Serial No. 10/797,645

Amendments to the Drawings:

REMARKS/ARGUMENTS

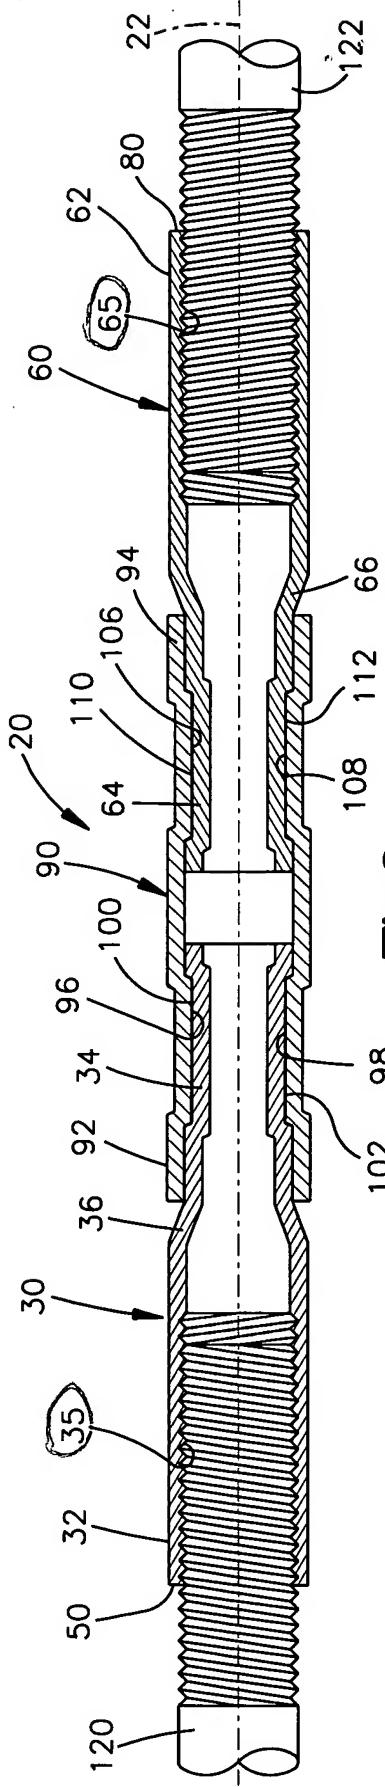
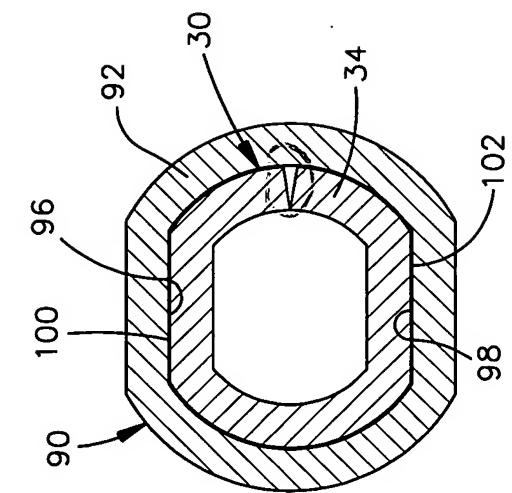
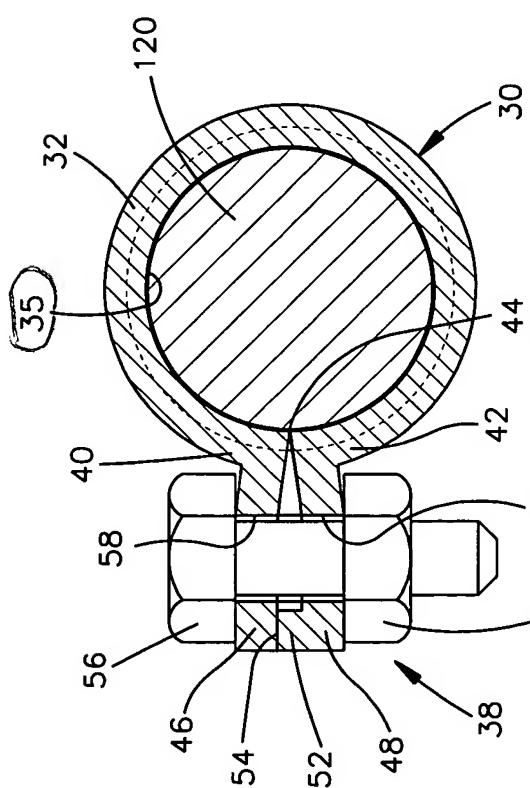
The attached sheet from the drawings includes changes to Figs. 3-5. The sheet replaces the original sheet including Figs. 3-5. In Figs. 3-5, reference character "35" is designated as the threaded portion of the first sleeve 30, and reference character "65" is designated as the threaded portion of the second sleeve 60. Fig. 5 is corrected to show the longitudinally extending seam 44. No new matter is added in these amendments to the drawings.

The drawings are corrected to designate reference character "35" as the threaded portion of the first sleeve 30, and reference character "65" as the threaded portion of the second sleeve 60. Figure 5 of the drawings is corrected to show the longitudinally extending seam 44. An annotated drawing sheet is provided that shows these changes marked in red. No new matter is added in the drawings by these changes. Therefore, the objection to the drawings should be withdrawn.
